B.M. ELEV.	
NO.	REVISIONS
01	ADDENDUM 1 - THERMISTOR RELAY 2019-08-22 CJR
00	ISSUED FOR CONSTRUCTION 2019-08-01 SLF
DATE	2019-05-20

ENGINEER'S SEAL  
 BID OPPORTUNITY NO. 630-2019

**THE CITY OF WINNIPEG**  
 WATER AND WASTE DEPARTMENT  
**NORTH END SEWAGE TREATMENT PLANT**  
 CONNECTION DIAGRAM  
 VFD-D375  
 MIXING PUMP  
 CITY DRAWING NUMBER: 1-0101D-E0025-001  
 SHEET 10 OF 44

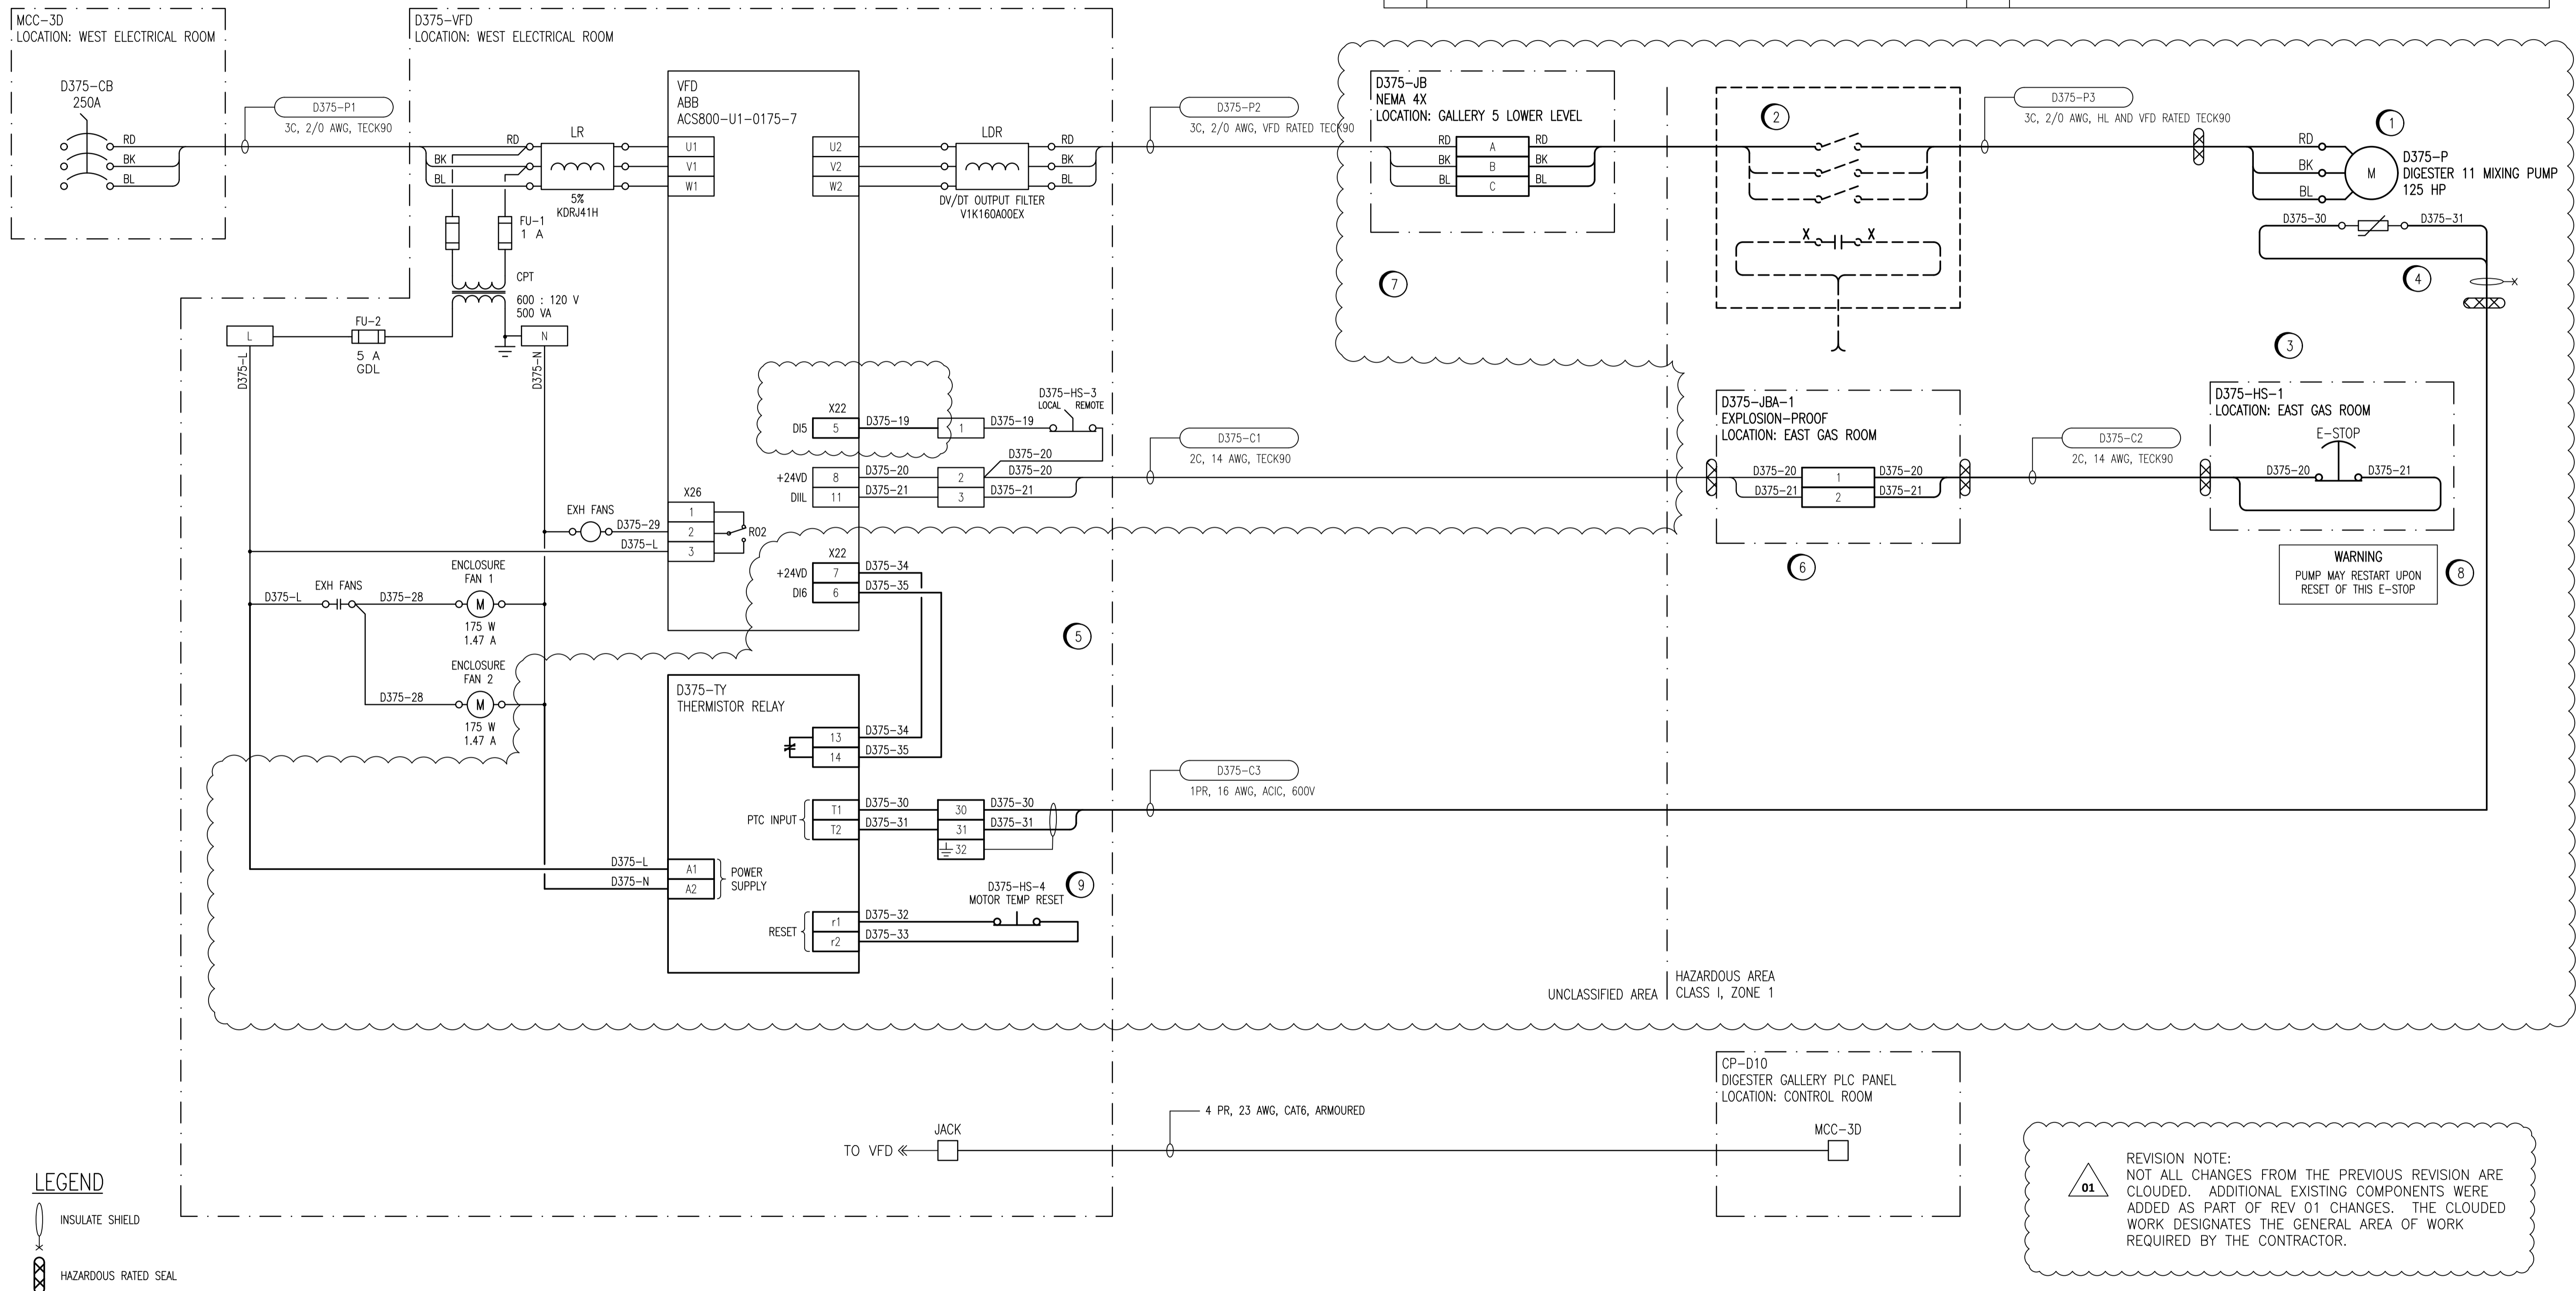
**REVISION NOTE:**  
 01 NOT ALL CHANGES FROM THE PREVIOUS REVISION ARE CLOUDED. ADDITIONAL EXISTING COMPONENTS WERE ADDED AS PART OF REV 01 CHANGES. THE CLOUDED WORK DESIGNATES THE GENERAL AREA OF WORK REQUIRED BY THE CONTRACTOR.

REVISION 01  
 THE ENGINEER'S DESIGN RESPONSIBILITIES ARE LIMITED TO THE CHANGES INDICATED IN THE CLOUDED WORK

- 1 REPLACE EXISTING MOTOR WITH NEW EXPLOSION-PROOF MOTOR.
- 2 DISCONNECT AND SALVAGE DISCONNECT SWITCH. REMOVE AUXILIARY CONTACT WIRING CURRENTLY INTEGRATED INTO E-STOP CIRCUIT.
- 3 INSTALL NEW EXPLOSION-PROOF EMERGENCY STOP SWITCH. RE-WIRE AS SHOWN.
- 4 RUN NEW CABLE AND CONNECT THERMISTOR WIRING AS SHOWN.
- 5 MODIFY VFD CABINET AS SHOWN. INSTALL DIN RAIL AND WIRING DUCT AS REQUIRED. SET VFD PARAMETERS AS REQUIRED AND COMMISSION.
- 6 REMOVE EXISTING NON-HAZARDOUS RATED JUNCTION BOXES. INSTALL NEW HAZARDOUS RATED JUNCTION BOX WITH TERMINALS TO EXTEND WIRING.
- 7 INSTALL NEW JUNCTION BOX WITH 200A RATED TERMINALS AND APPROPRIATELY SIZED FOR CABLE BEND RADIUS. LOCATE IN CEILING SPACE OF GALLERY BELOW THE EAST GAS ROOM.
- 8 PROVIDE WARNING LAMACOID IN ACCORDANCE WITH E14.
- 9 INSTALL NEW RESET BUTTON IN THE DOOR.
